INCH-POUND
MIL-L-3661/61C
AMENDMENT 1
15 SEPTEMBER 2003

MILITARY SPECIFICATION SHEET

LAMPHOLDER, LIGHTS, INDICATOR (HOUSING), STYLE LH94

This amendment forms a part of MIL-L-3661/61C dated 25 October 1978 and is approved for use by all Departments and Agencies of the Department of Defense.

FIGURE 3. Midget screw lamp socket.

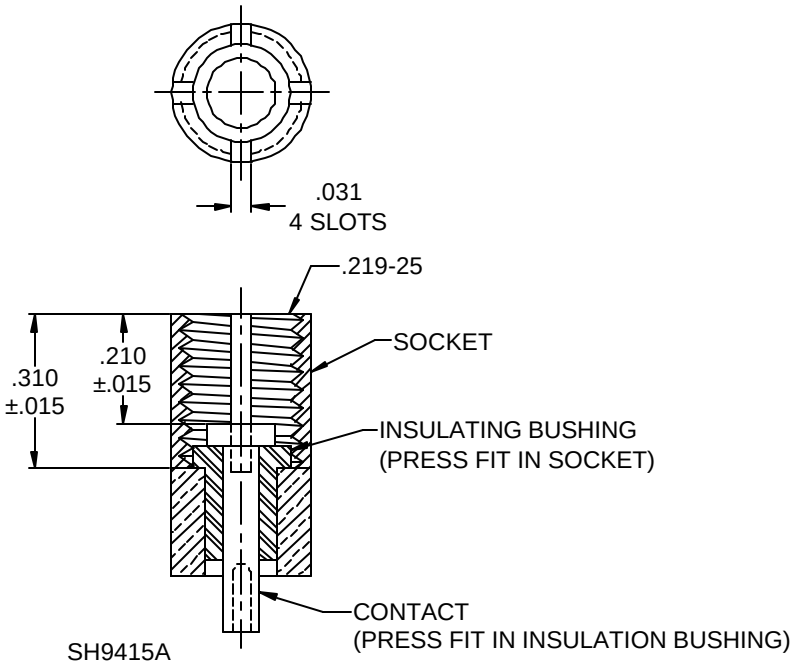
FIGURE 3: Delete and substitute:
